Vogtle Electric Generating Plant
NUCLEAR OPERATIONS

Procedure No.
00400-C
Revision No.
11
Page No.
1 of 33

PLANT DESIGN CONTROL

Project	VOGTLE	Designed By	DAVID WHITEHURST	Date	3-21-90
Subject	500KV MAIN BREAKER CT CONNECTIONS	Reviewed By		Sheet	4
		Calculation Number

Project VOGTLE	Prepared By DAVID WHITEHURST	Date 3-21-90
Subject Title 500 KV MAIN BREAKER CT CONNECTIONS	Reviewed By	Date
	Calculation Number	Sheet 2 of 4

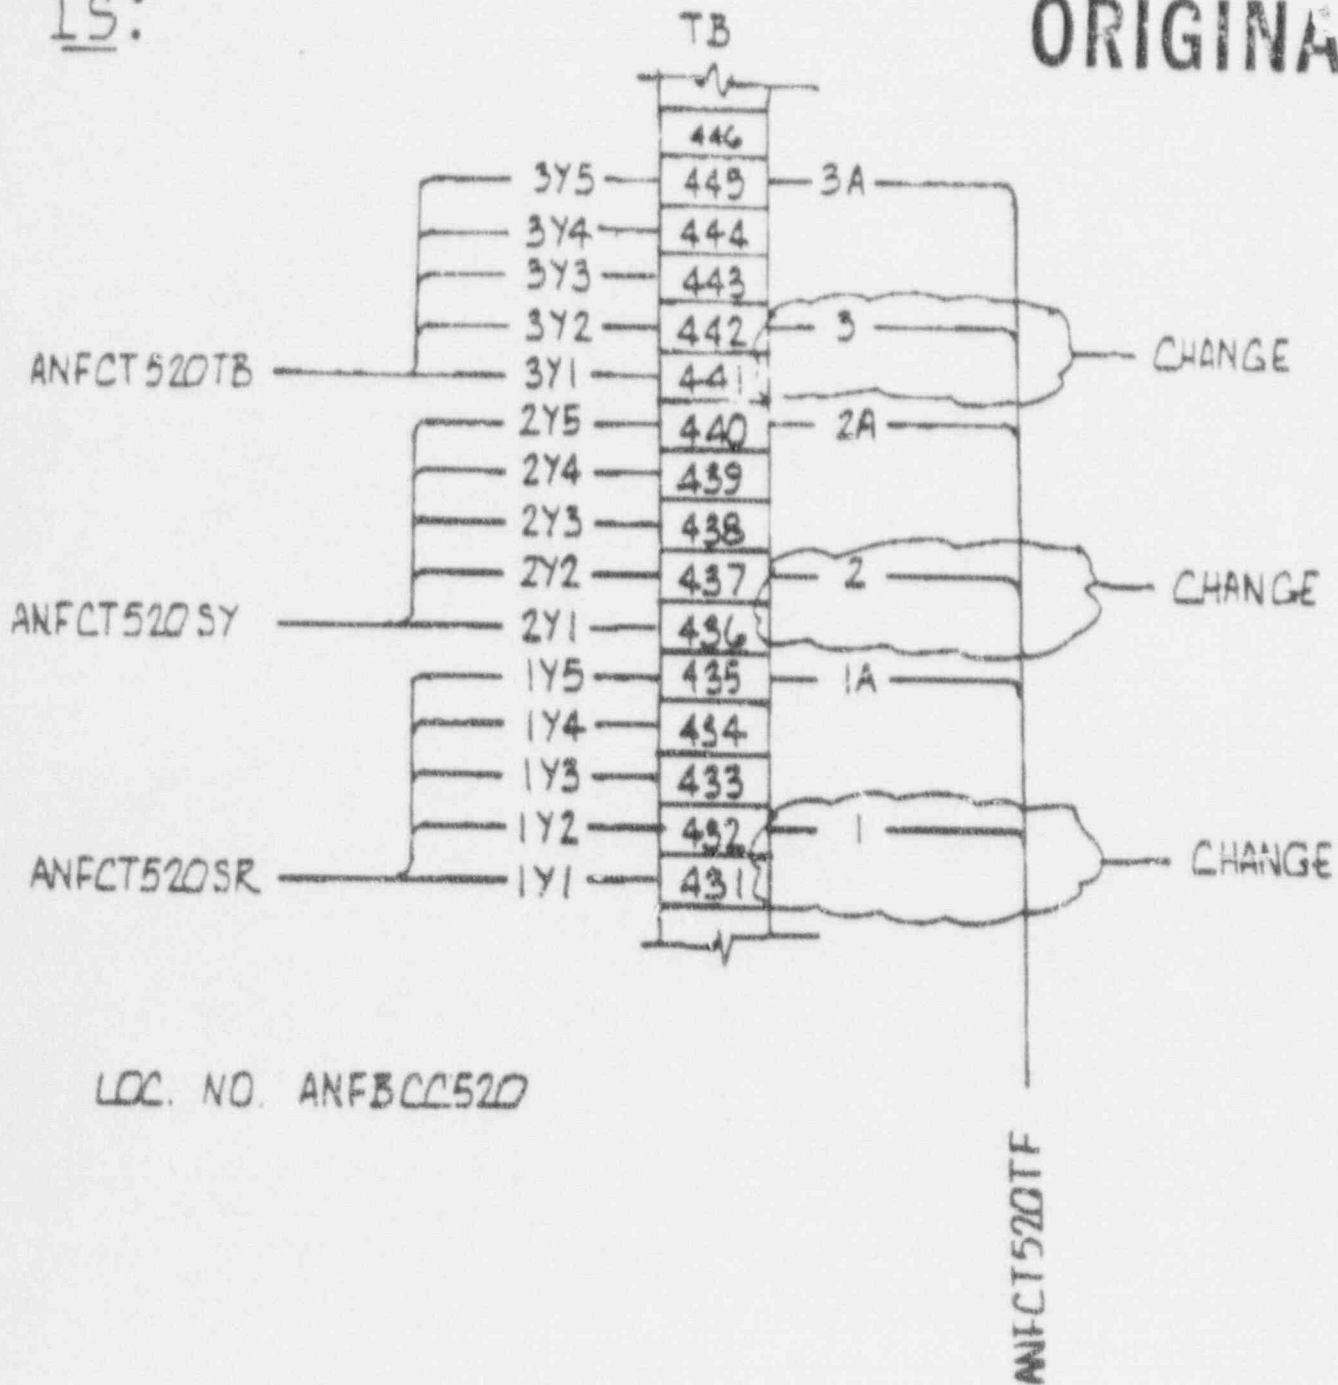
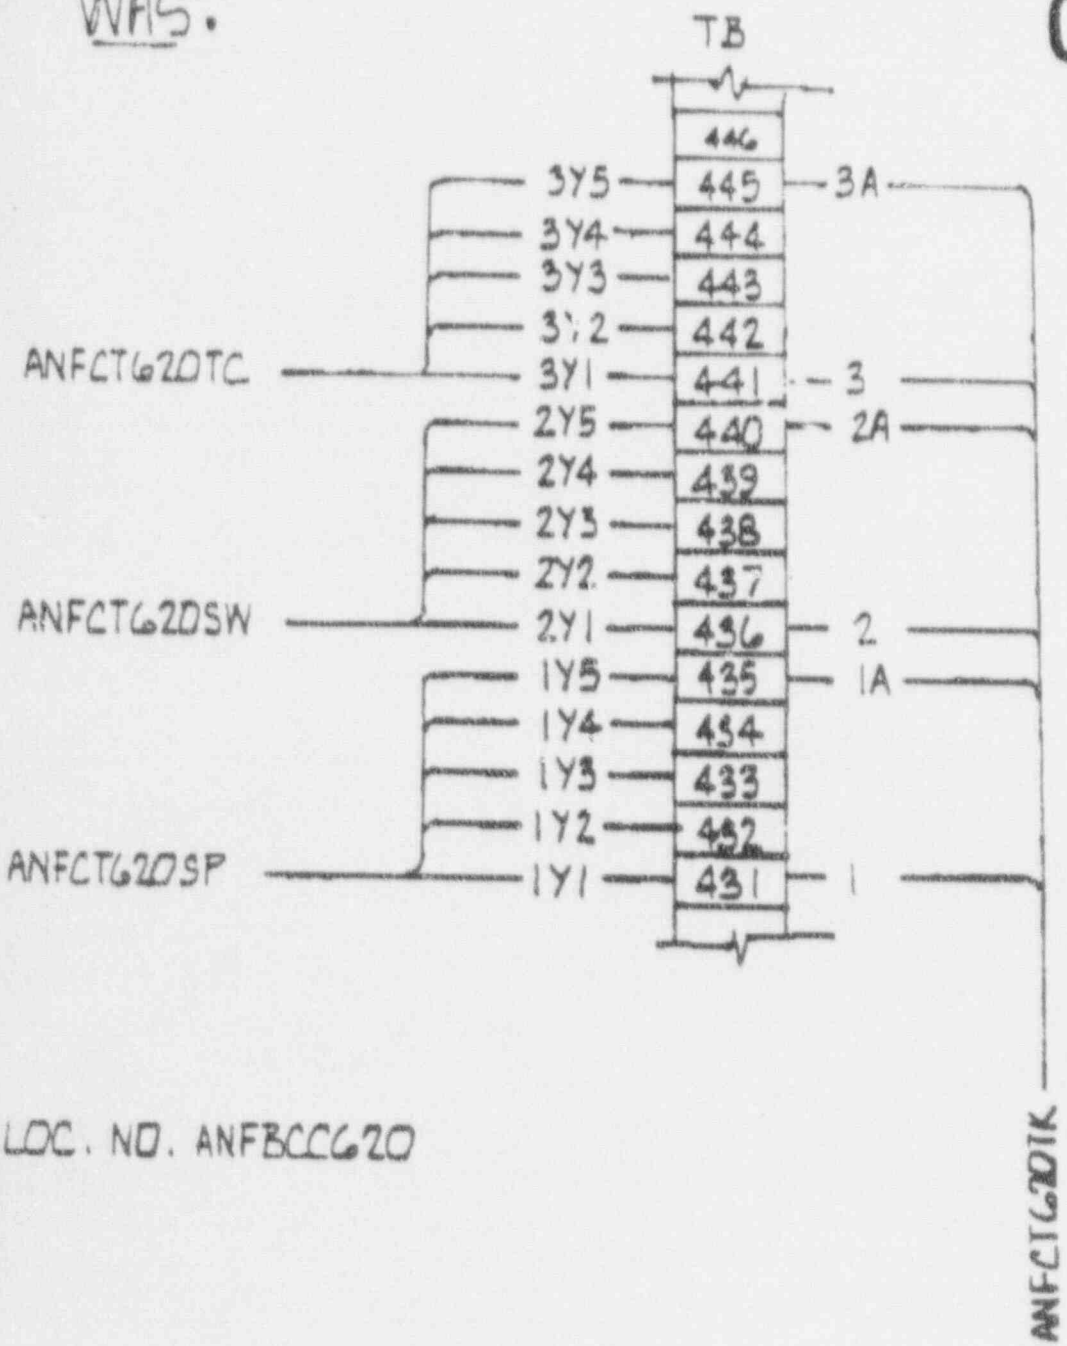
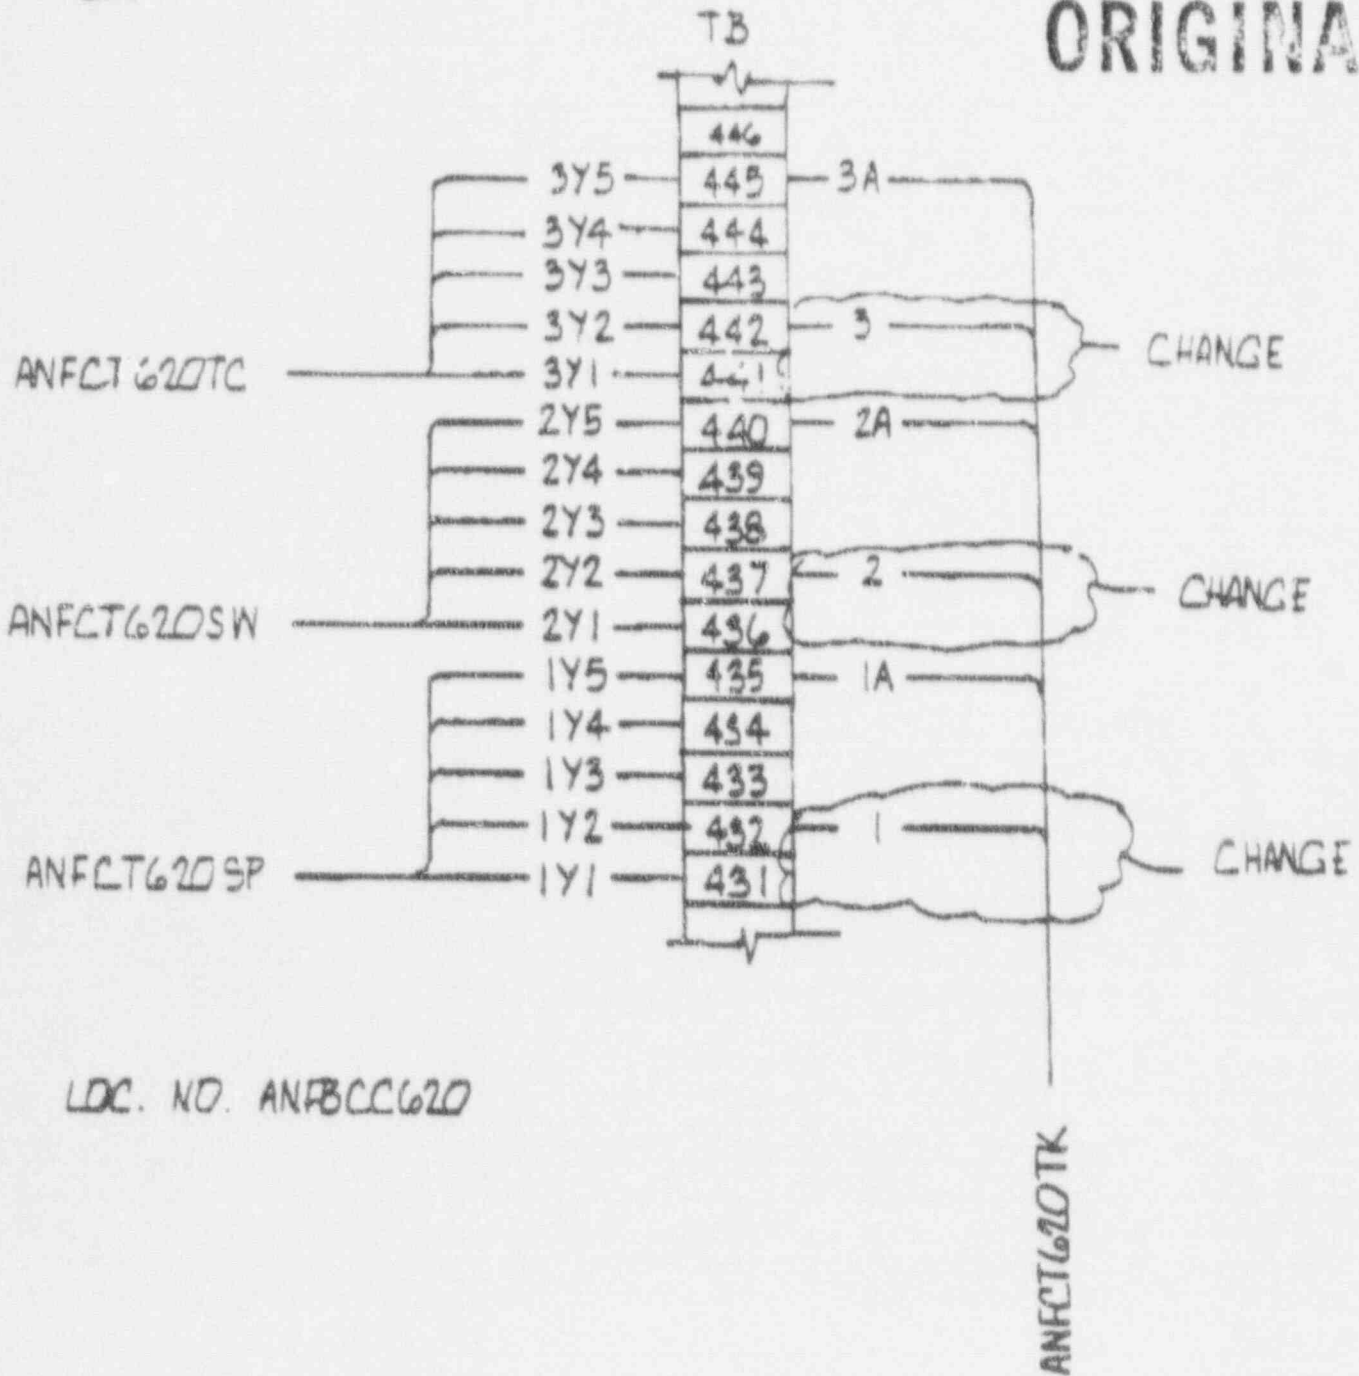
5) Disposition: Change tap settings on
breakers PCB161530 and PCB
1615630 per attached. Breaker data
sheet requires the relay to be set for
a 2000 to 5 winding however the
wiring diagrams AX30-CA-L73T and
AX30-CA-L73P show a 3000 to 5
condition. The relay was set to the
2000 to 5 winding however the
taps were set to 3000 to 5.
